Service Bulletin: SB407-101; Bell 407 Air Conditioner Compressor Drive Pulley.

Subject: Inspection & Torquing Procedure for the Air Conditioner Compressor Drive Pulley Installation.

Date: 4 March, 1999
28 Sept. 2000, Rev A

Applicability: Bell 407, Equipped with the Air Comm Corporation 407EC-201 Air Conditioner System.

Figure 1 Compressor Drive Pulley Installation Details

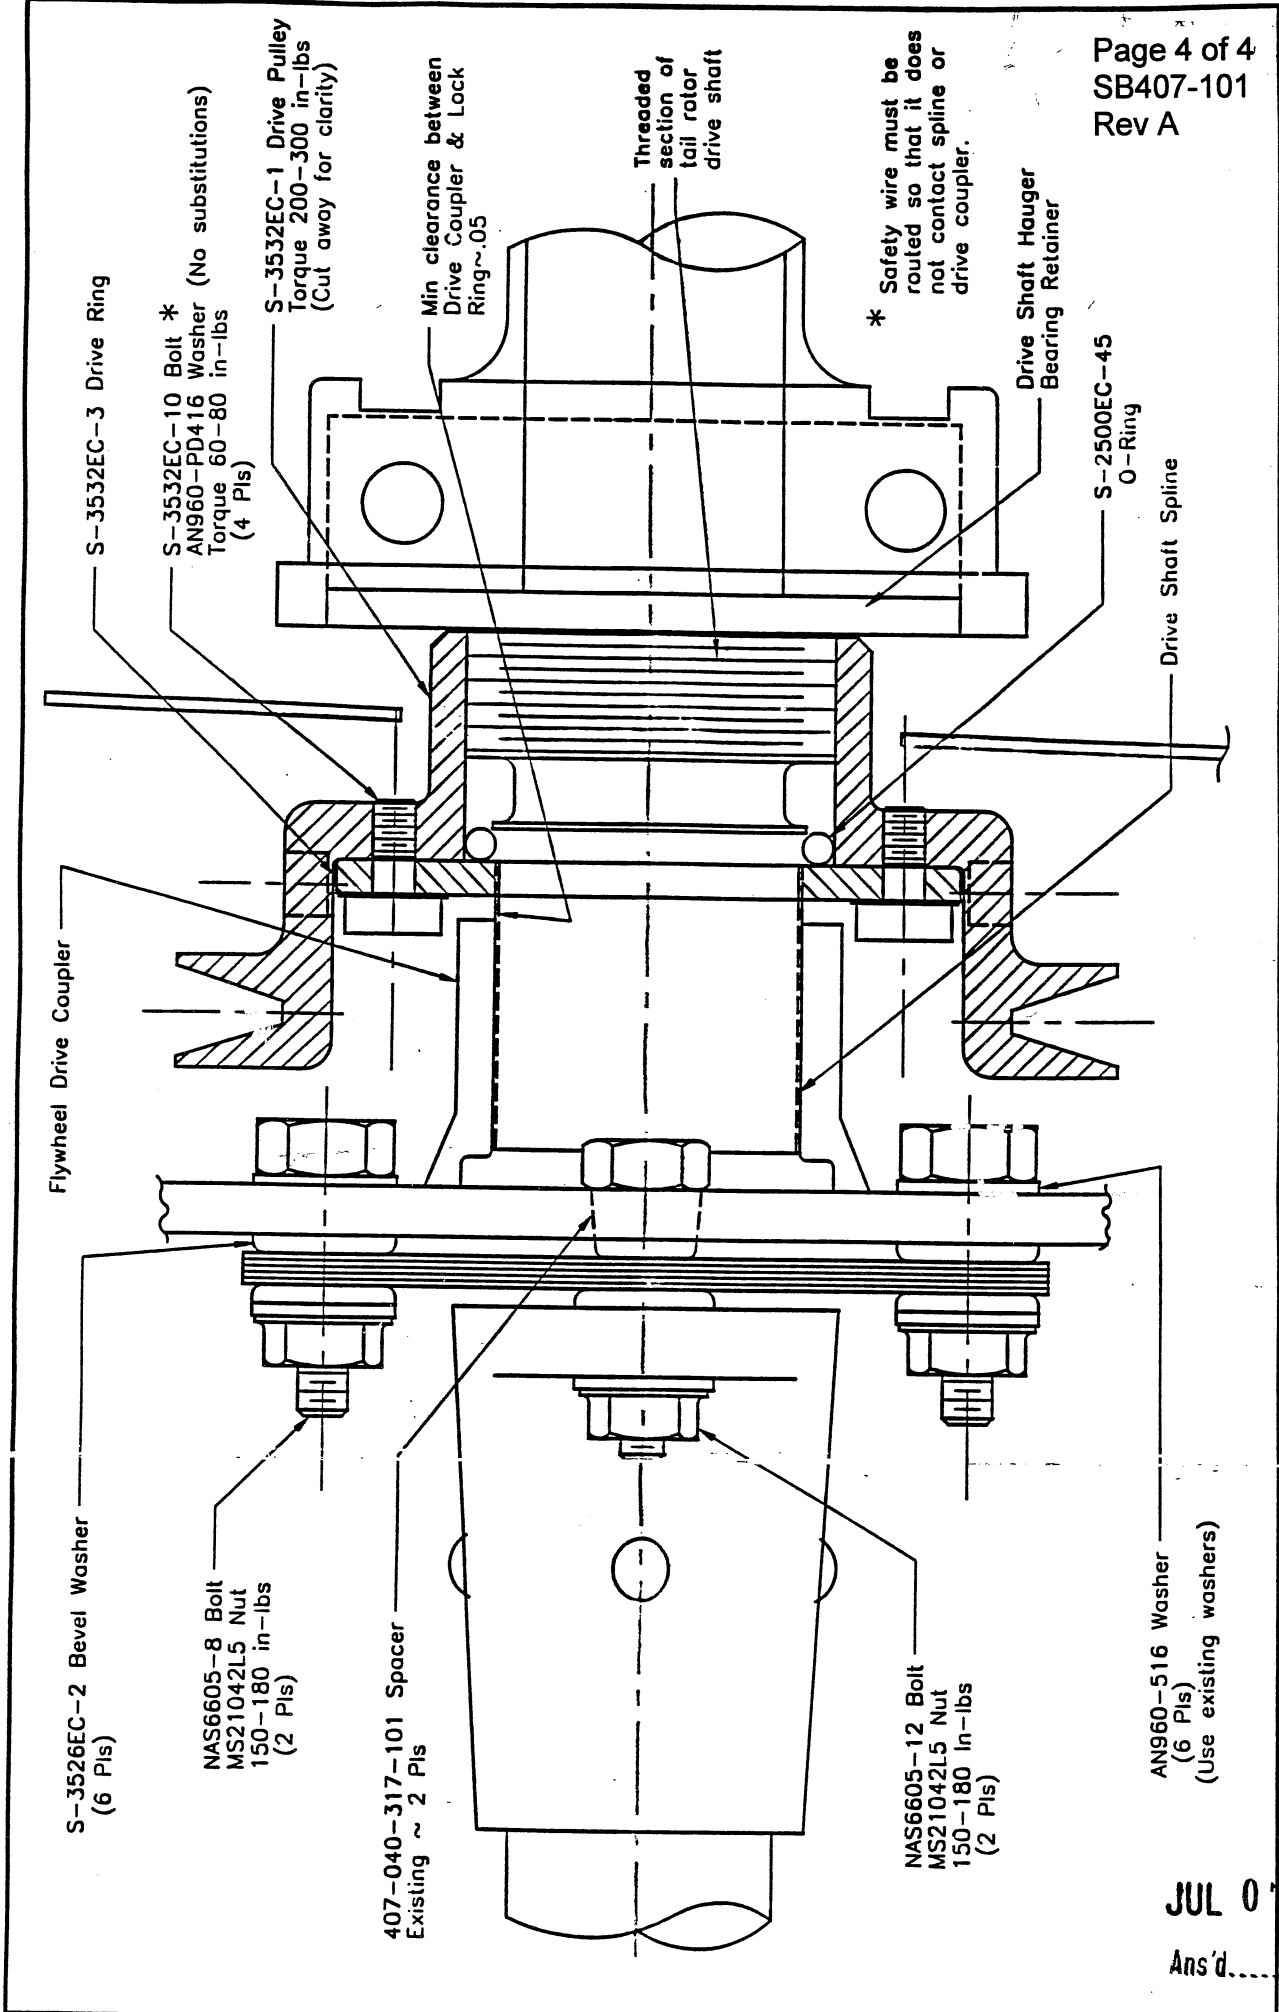
- e. Install Flywheel Drive Coupler, Flywheel and existing Drive Shaft mounting hardware as shown on Page 4 of 4, torque nuts to 150 –180 in lbs.

Minimum clearance between the Flywheel Drive Coupler, and the Drive Ring is .050 inch.
